Service Bulletin

Bulletin No.: 20-NA-020

Subject: Brake Squealing Noise

Brand:	Model:	Model Year:		Date Breakpoint:		Engine:	Transmission:
Dianu.		from	to	from	to	Engine.	mansinission.
Chevrolet	Silverado 2500HD/ 3500HD	2020	2020	SOP	September 01, 2019	-	-
GMC	Sierra 2500HD/ 3500HD	2020

5638981

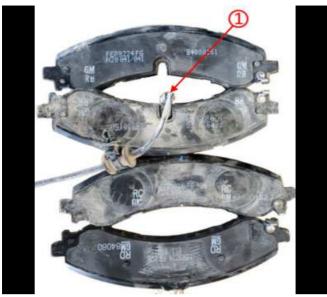
Involved Region or Country	United States, Canada, Mexico, Middle East, Israel		
Condition	Some customers may comment that the brakes are squealing.		
Cause	This condition may be caused by a low scorch friction material was used on the original brake pads.		
Correction	Replace the front and rear brake pads.

Note: Each brake pad is labeled with an Inner or Outer to indicate where to be installed.

New pads have a "high scorch" friction material. Current parts in inventory are the new design.

If the pads have already been replaced and the noise persists, check the orientation of the pads. There is an inboard and outboard designation on the pads. If they are in the wrong location, a brake noise can result.
